Our Ref: 110965.02 - Westlink Lot 4 - Response to Agency Comments on Stormwater.docx
PJM:pjm

Subject: Westlink Lot 4 --(SSD-9138102 Mod 2) Response to Penrith Council's Comments on Stormwater

Subject: Westlink Stage 1, Abbots Road Kemps Creek– Civil Infrastructure Design – Certification Relative to Condition B25 (k)

ATTACHMENT B - WESTLINK – CATCHMENT REDISTRIBUTION

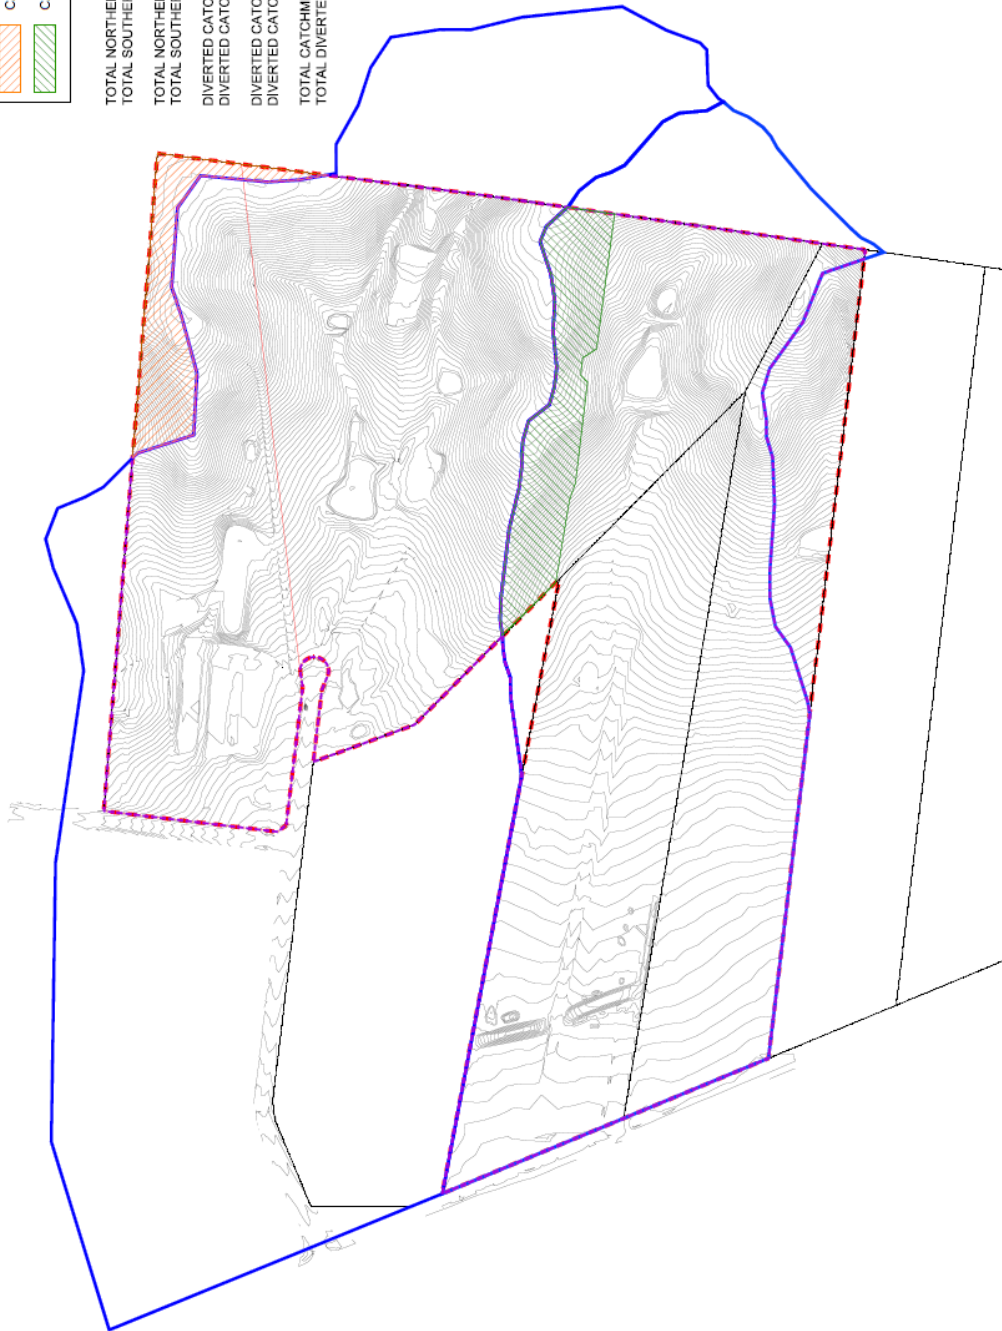
8.	Catchment Redistribution		
	<p>Consistent with Sydney Waters verbal advice at the meeting of 17/4/23 ESR is proposing to redirect a maximum of 10% of the catchment areas discharging to each channel when compared to the post-development catchments detailed in the IWCM strategy.</p> <p>JWP issued an email and plan outlining intended catchment diversions on 18/5. On 24/5 SWC requested further details clarifying the treatment of the catchment in the NW corner of the Westlink site. JWP updated and reissued the plan to Sydney Water on 26/5. A copy of his sketch plan is provided in Attachment B.</p> <p>SW noted (AT email 30/5) that the proposed catchment redistribution exceeded the agreed 10% permissible limit but nevertheless confirmed that in this instance SW could facilitate the proposed change to catchments</p>	Noted

ATTACHMENT C - WESTLINK – 20 m CHANNEL OPTIONS

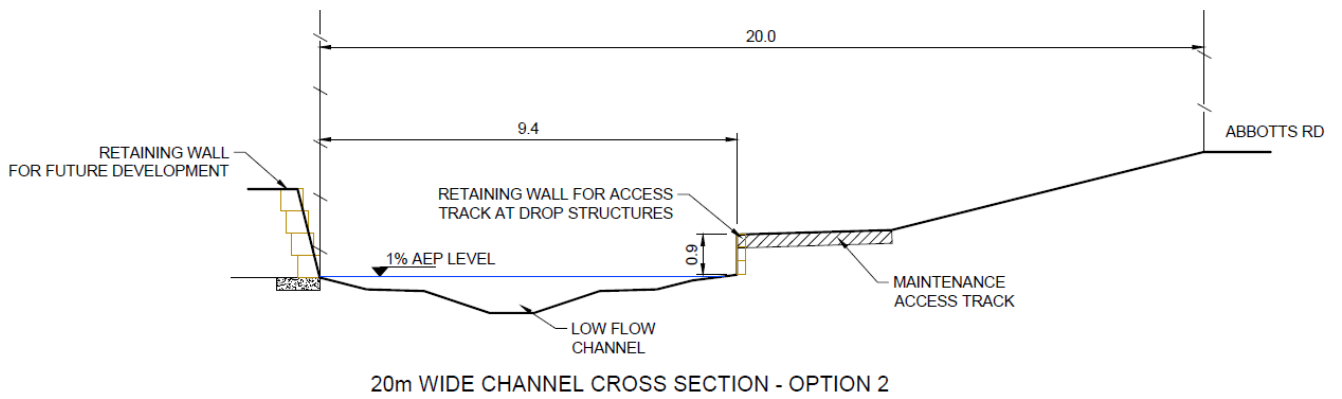
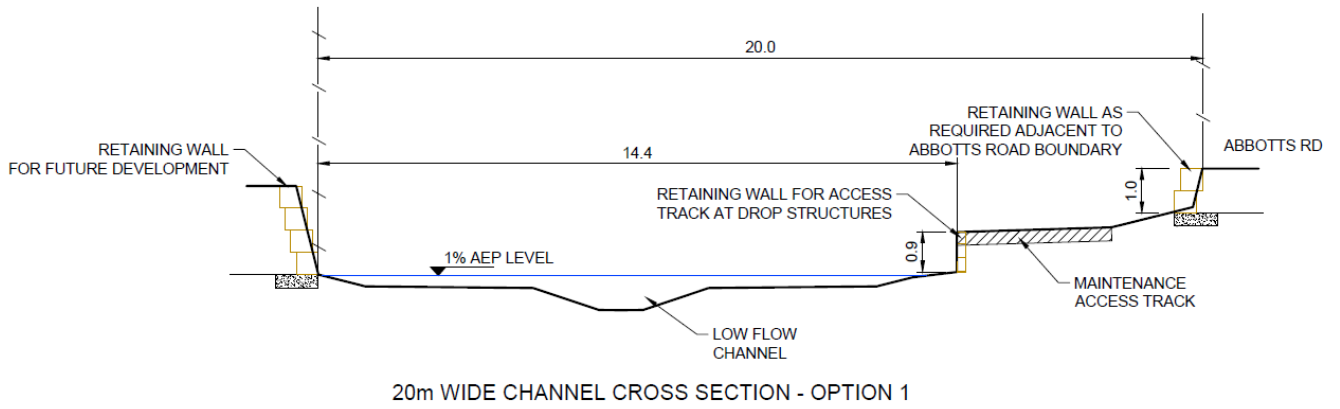
5.	Channel Width						
5.1.	<p>Would a reduced channel width be permitted for Stage 1 if we can demonstrate that the flows are contained, and the design complies with the technical guidelines?</p>

<p>SWC was inclined to agree with a reduced channel width (down to a min 20 m) where flows permitted.</p> <p>SWC was currently reviewing the precinct hydrology modelling to confirm appropriate modelling parameters.</p> <p>To allow advancement of the channel design within the required timeframes for Stage 1:</p> <ul style="list-style-type: none"> • SW (PG) provided details of the flows they had previously estimated at Aldington Road on 18/5. (Pre-development 1% AEP = 5.1 m³/s at Aldington Rd) • AT&L prepared a brief summary letter outlining key hydrologic modelling parameters applied to the DRAINS modelling for Westlink and the stage 1 channel. GM issued this to SW on 15/5. • JWP confirmed the adoption of AT&L's pre-development 1% AEP flow estimates of 7.2 m³/s at the western boundary for the design of the entire trunk drainage channel. • SW (JM) responded with initial comments by email on 25/5 to specific questions raised by AT&L relating to broader precinct scale hydrology for the Mamre Road Precinct. SW advised AT&L there would be further advice forthcoming on losses to be applied in the hydrological modelling. • JWP (DG) presented two alternate channel sections by email 5/6 that achieved a 20 m TD corridor width while complying with design arrangements agreed in principle (Option 8). Indicative cross sections of each option are provided in Attachment C. • SW to review and confirm the preferred Option. • SWC requested additional information on the 20m wide channel options, including overbank velocities for the establishment phase, channel profiles with additional profiles overlaid (Abbotts Road CL, boundary, maintenance track and channel banks) and preliminary hydraulic results. • JWP provided the additional information above along with 3D images of the channel profile. SWC to review and confirm the preferred option. • SWC agreed to the Option 1 20 m wide cross section at the meeting of 14/6/23. 	<p>JWP (Integrate into Design)</p>
